PLAN REVIEW SHEET

Petition: 2015-014

Park Sharon Properties, LLC Email:

Waiting Pad Detail

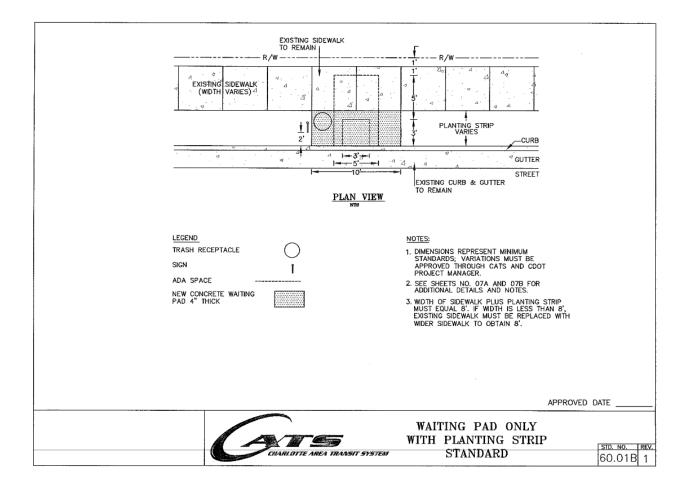
The Petitioner is requested to provide and construct a concrete pad for the existing bus stop on Sharon Road. Below is an image of the standard detail (60.01B) for the requested concrete pad. The site plan may either show the conceptual location of the improved bus stop on Sharon Road, or alternatively, include a development note to locate the bus stop pad during the urban review process.
